TROJAN NUCLEAR PLANT

AMENDMENT TO FACILITY OPERATING LICENSE

Amendment No. 140  
License No. NPF-1

ATTACHMENT TO LICENSE AMENDMENT NO. 140

FIGURE 6.2-1 OFFSITE ORGANIZATION

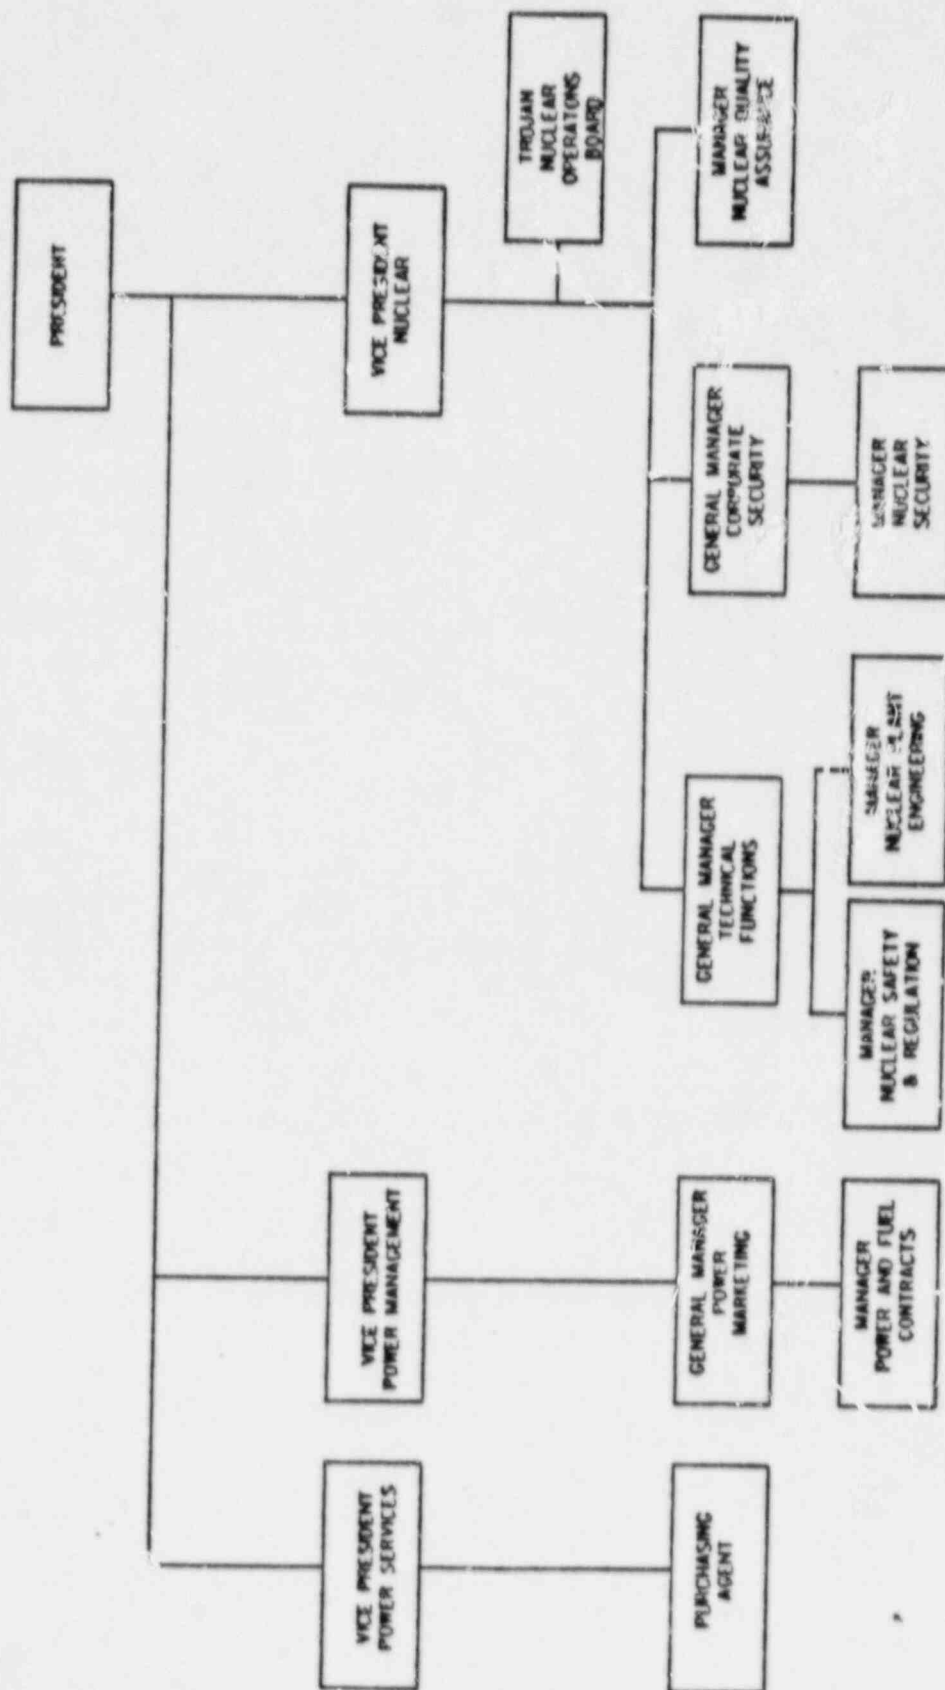
Revise Appendix A as follows:

Remove Pages

6-2

6-3

6-6

Insert Pages

6-2

6-3

6-6
